# Staff Report

To: Salt Lake City Planning Commission  
From: Casey Stewart; 801-535-6260  
Date: April 17, 2014  
Re: PLNPCM2014-00045 Conditional Building and Site design for 151 Tower Office Building

## CONDITIONAL BUILDING AND SITE DESIGN REVIEW

**PROPERTY ADDRESS:** 145 South State Street (to be re-addressed as 151 South State St)

ORIGINAL DESIGN

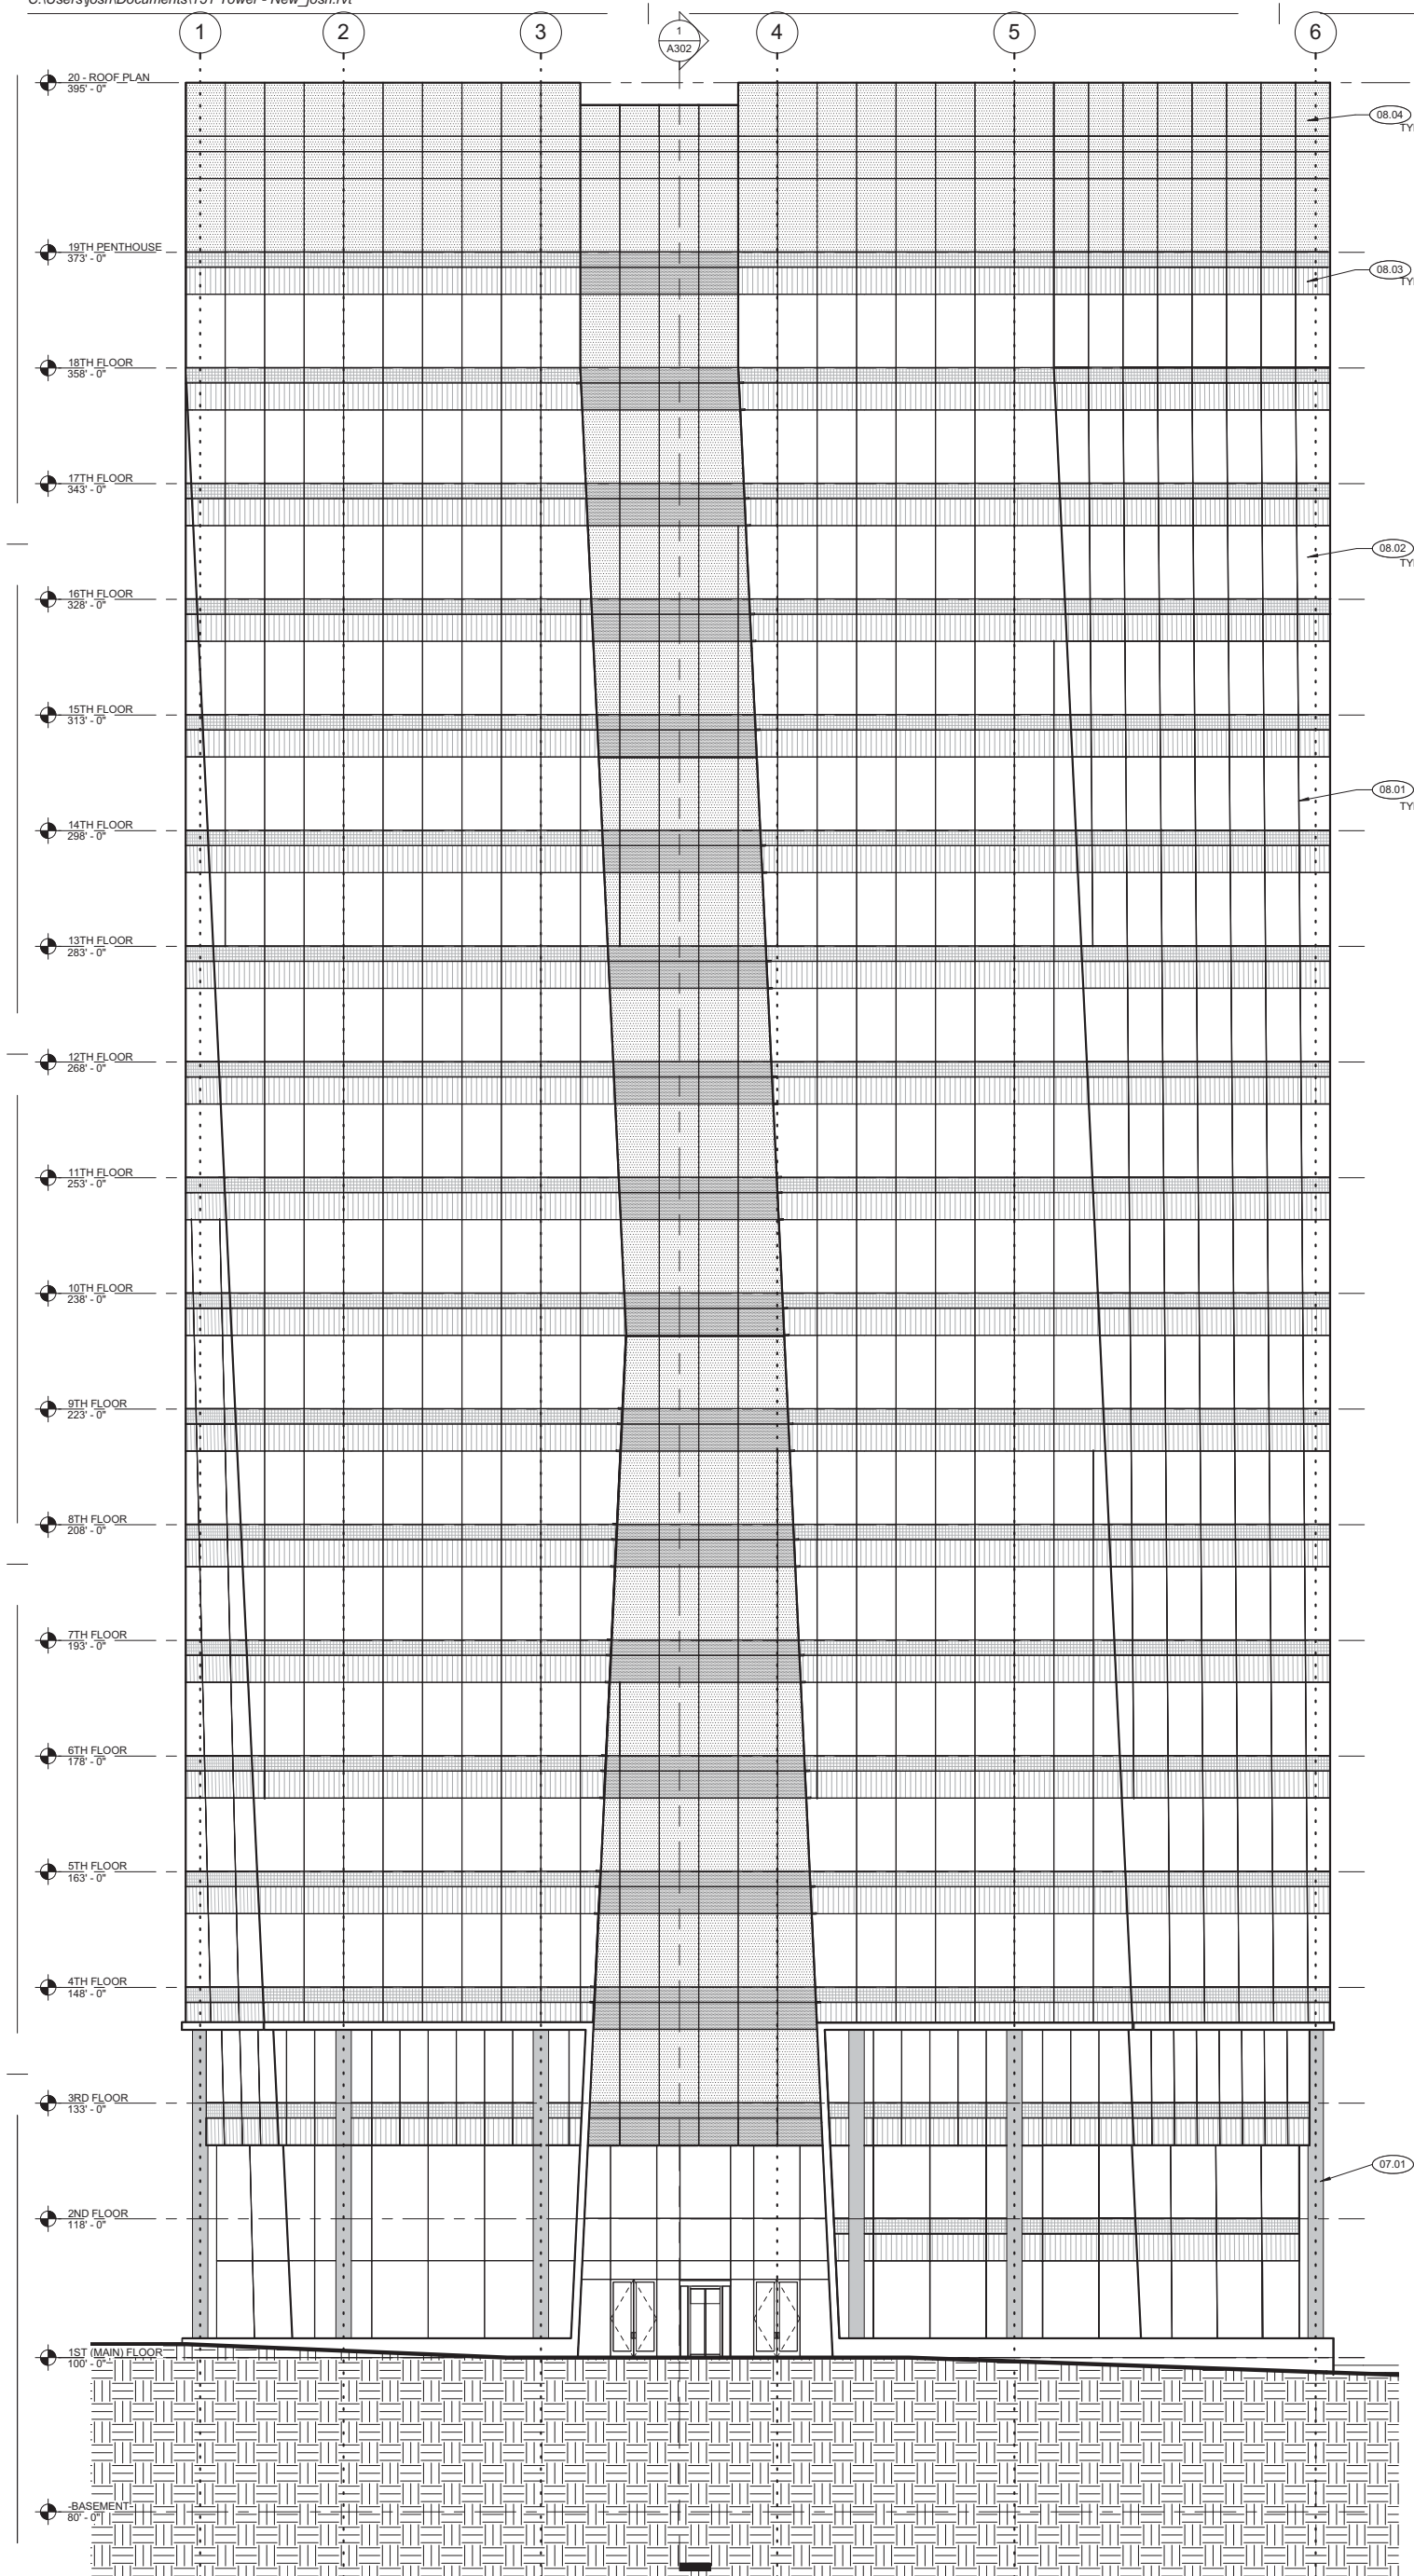
**Issue 1: Roofline architecture - unresolved**

The original roofline architecture was very similar to other recent office tower projects at 222 South Main Street (completed) and 111 South Main Street (under construction). These buildings have flat rooflines consisting of glass parapets. A district roofline is a criterion when seeking extra building height. Based on initial planning staff concerns of an indistinct roofline (when compared to those recent projects), the applicant modified the roofline in an attempt to meet the criterion; however this latest roofline version does not sufficiently distinguish itself from the other projects, or the original roofline design – especially for the amount of extra height requested.

The building design overall uses varying angles and cuts to create subtle visual illusions of building form; and the proposed roofline continues this theme, but its similarities with other recent buildings remains readily apparent. Both designs proposed by the applicant are included with this report for the planning commission's consideration. Lacking more distinct roofline architecture, planning staff cannot fully recommend in favor of the extra building height requested, as discussed in the analysis that follows.

**1 WEST ELEVATION**  
 A201 scale: 3/32" = 1'-0"

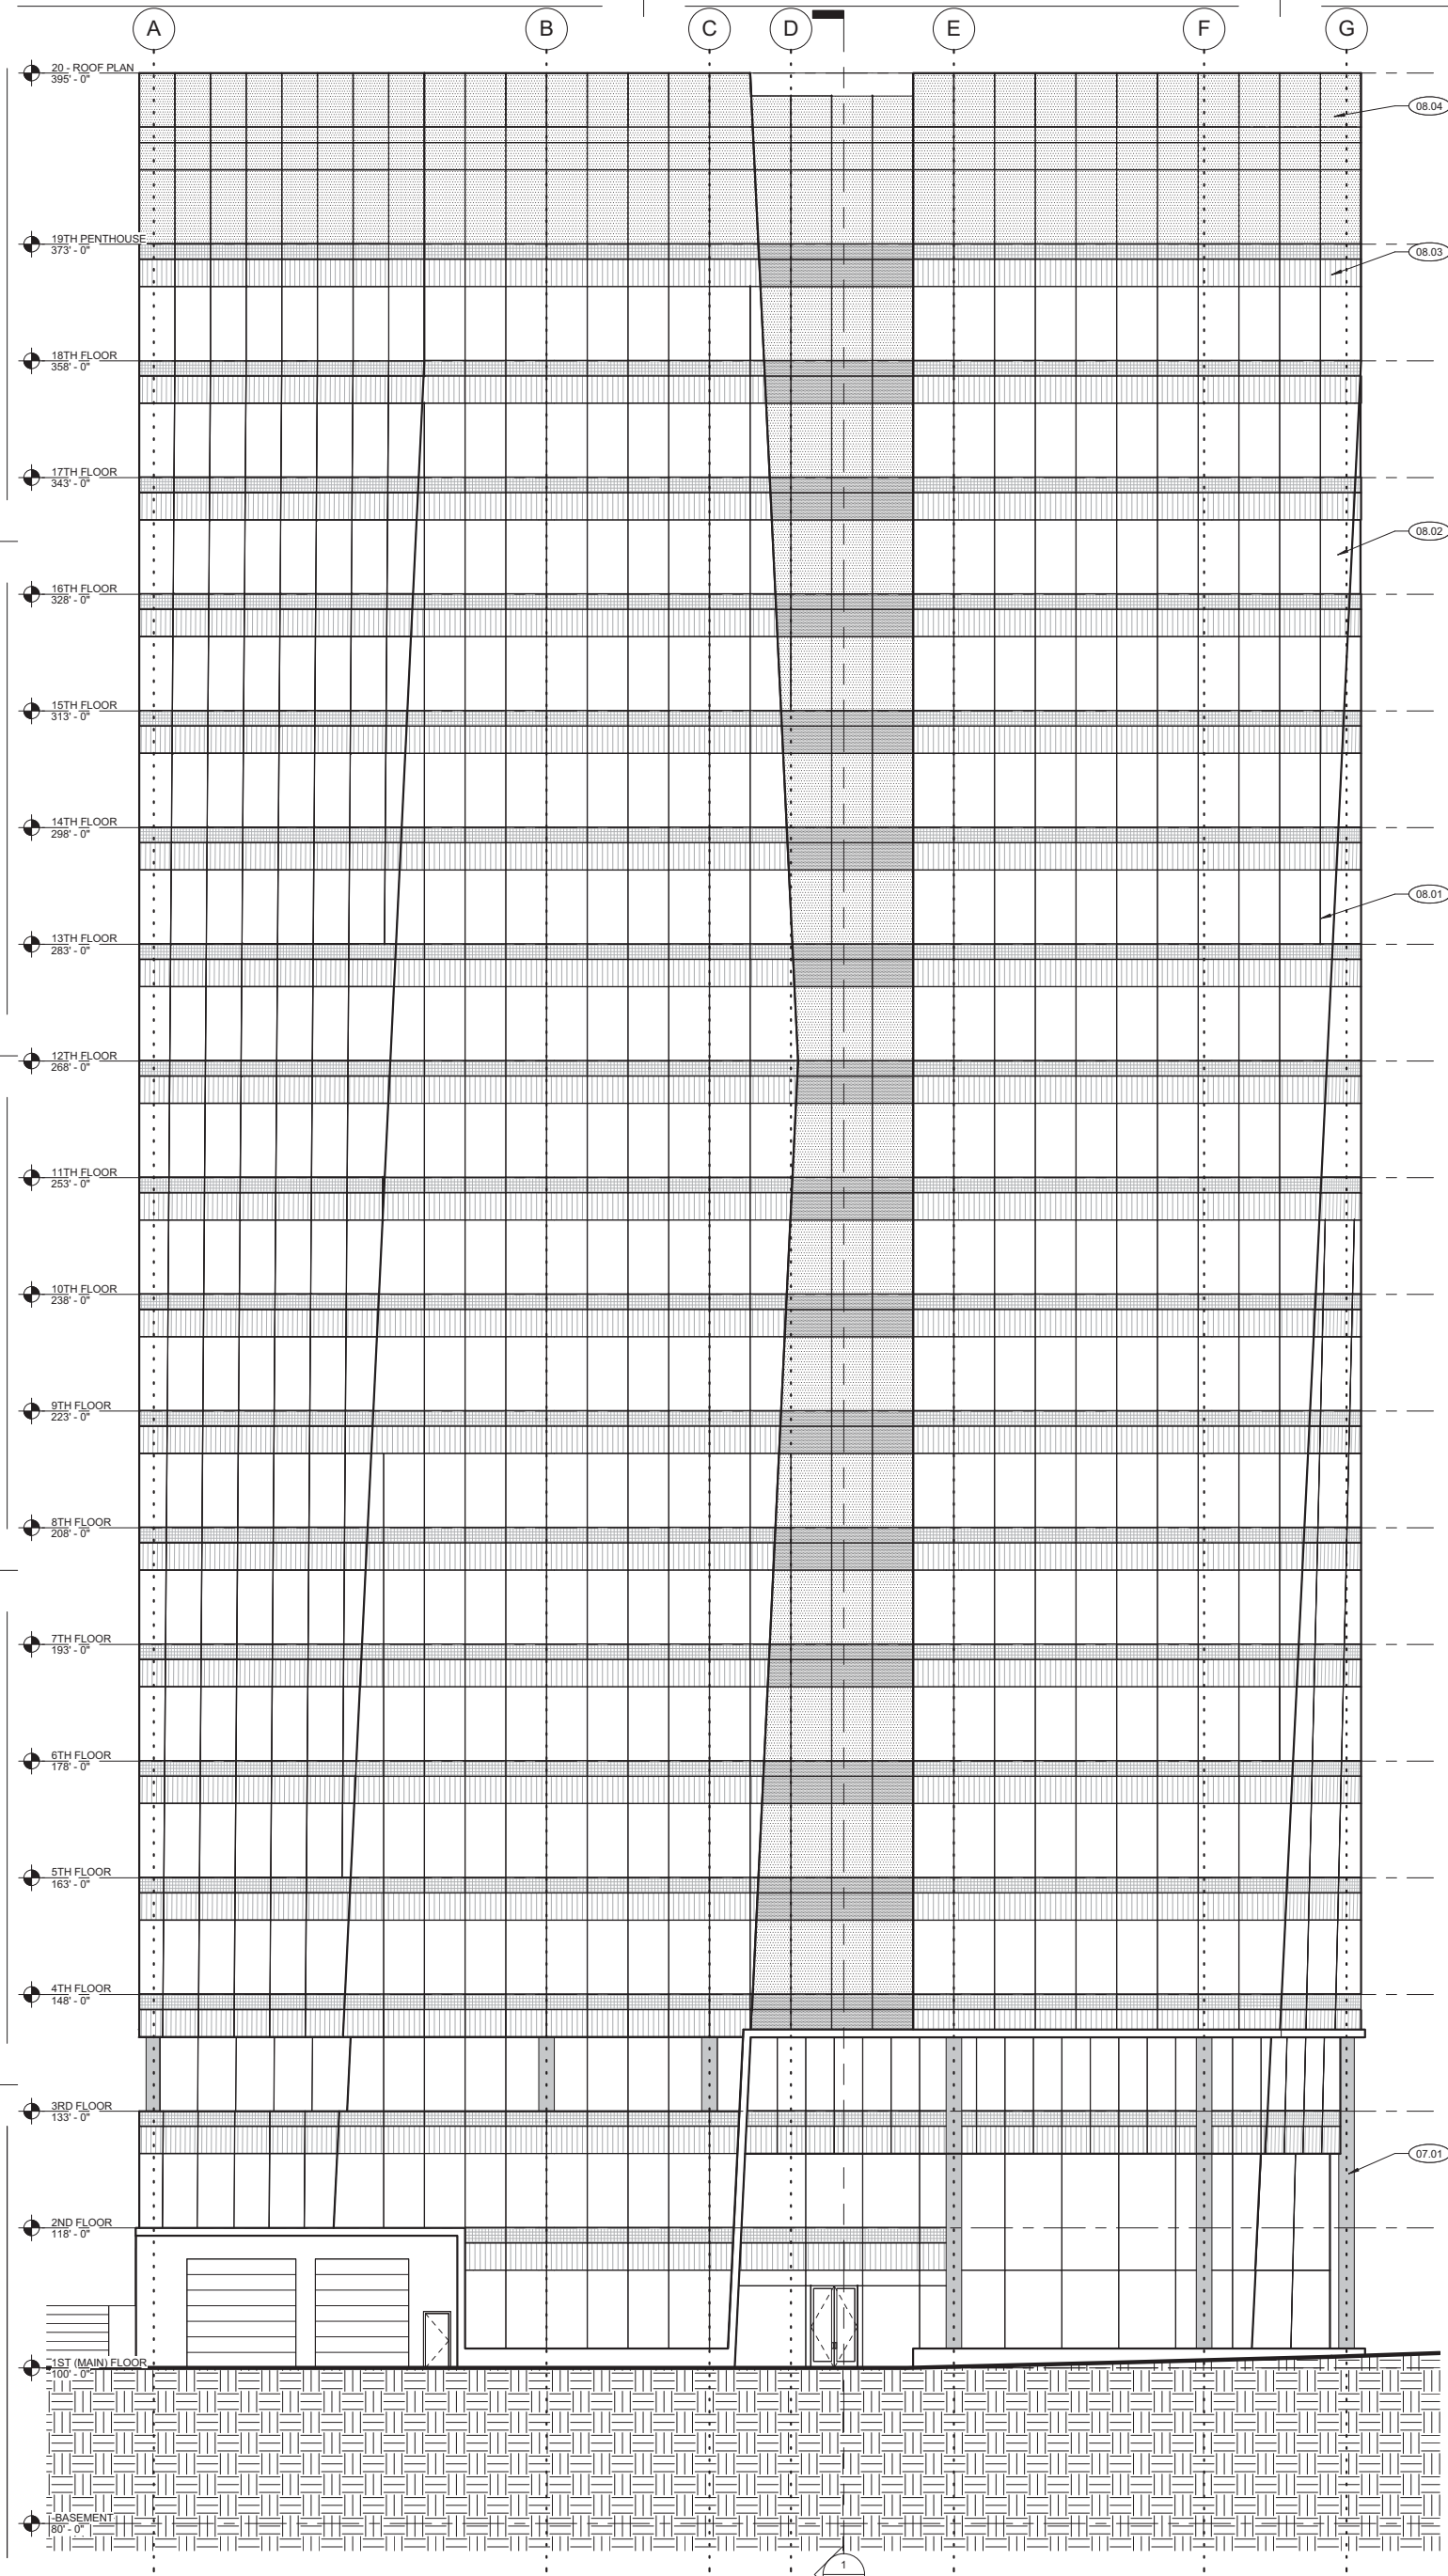
**REVISED PARAPET DESIGN**

We played around with a dozen options this week for the parapet for 151 which included cutting off the glass parapet around the building at a slight angle, extending the penthouse taller than the glass parapet to create a step in the façade similar to the step in the façade from the third floor to the fourth floor, different shapes for the penthouse itself, sloping just the top of the penthouse and exposing it above the glass line, etc., etc. We only came up with one option that we feel can meet the intent of the ordinance and strengthen rather than compromise the design. (See attachment)

The modified design involves three revisions from the original design submitted to the City:

1. Modulate the top of the parapet more by greatly increasing the vertical depression at the niches. We originally had two feet drops in the top of the glass parapet at the niches and now we are proposing six feet. With three times more variation in the top of the building cornice line than we had in original design, it strongly accentuates the four quadrants of the building façade as independent masses separated by the niches. This castellation of the façade is very distinct from the 111 Building which has no relief in either the face or top of its parapet wall. It also is more uniform and complete in its appearance from that of the 222 Building which, while it has a dressed up front façade, reverts to exposed penthouse boxes on the backside of the building.

2. We have modified the glass parapet from the frosted glass in our original design, to nearly clear glass which is also different than any other building in the downtown, including 111, and 222.

3. We have suggested a subtle pattern be included on the face of the penthouse so that it becomes an integral part of the design, not just a mechanical box we are trying to hide. The actual pattern (shown as vertical grey shapes in the rendering) may take more time to fully develop, but we have shown a concept that integrates the vertical lines of the top of the building in an artistic vertical expression.
